# Access Compliance Report

## Public Rights-of-Way

Intersection ID: 48631	Main Street: MILLBROOK_RD	Cross Street: WATER_OAK_RD	Location: SE
ADA ID: BF68BBB0E1BD	Ramp Type: PerpDiag	Initial Pass/Fail: Fail	Overall Compliance: No
Severity Score: 21.25			
Codes/Mitigation Info/Possible Solution		Field Measurements/Component Compliance

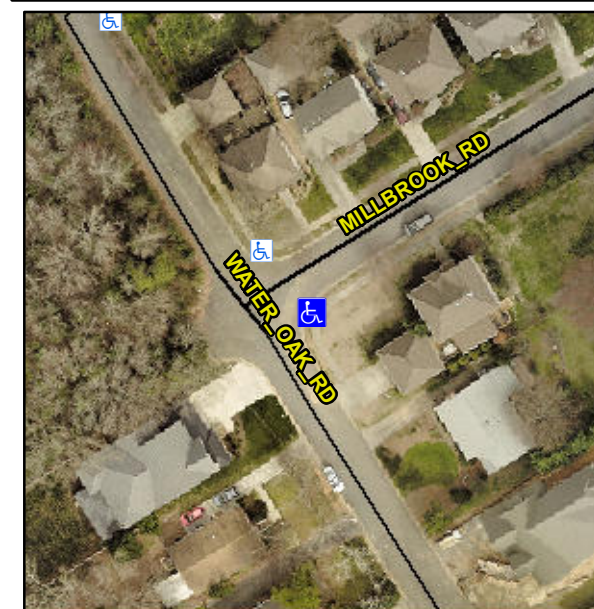
**Not Found, R304.5.1, R304.2.2**

Compliance	Description	Data	Compliance	Description	Data
N/A	Ramp Length (in)	47.0	No	Ramp Slope (%)	11.1
No	Ramp Width (in)	47.0	Yes	Ramp XSlope (%)	1.6
N/A	Flare Type LT	N/A	N/A	Flare Type RT	N/A
N/A	Flare Slope LT (%)	N/A	N/A	Flare Slope RT (%)	N/A
N/A	Flare Traversable LT?	N/A	N/A	Flare Traversable RT?	N/A
N/A	Landing Length (in)	N/A	N/A	DWS Provided?	N/A
N/A	Landing Width (in)	N/A	N/A	DWS Contrast?	N/A
N/A	Landing Slope (%)	N/A	N/A	DWS Length (in)	N/A
N/A	Landing X Slope (%)	N/A	N/A	DWS Full Width?	N/A
N/A	Landing Curb? (Y/N)	N/A	N/A	DWS Offset (in)	N/A
N/A	Shared Landing?	N/A			
N/A	Gutter Ponding?	N/A	N/A	Gutter Slope (%)	N/A
N/A	Gutter Lip Ht (in)	N/A	N/A	Gutter X Slope (%)	N/A
N/A	Painted X Walk1?	No	N/A	Painted X Walk2?	No
	X Walk 1 Direction	To NW		X Walk 2 Direction	To W
N/A	X Walk 1 Width (in)	N/A	N/A	X Walk 2 Width (in)	N/A
	X Walk 1 Slope (%)	1.3		X Walk 2 Slope (%)	1.9
	X Walk 1 X Slope (%)	2.8		X Walk 2 X Slope (%)	0.3

**Remove & Replace Curb Ramp With Two New Directional Ramps or Equivalent.**
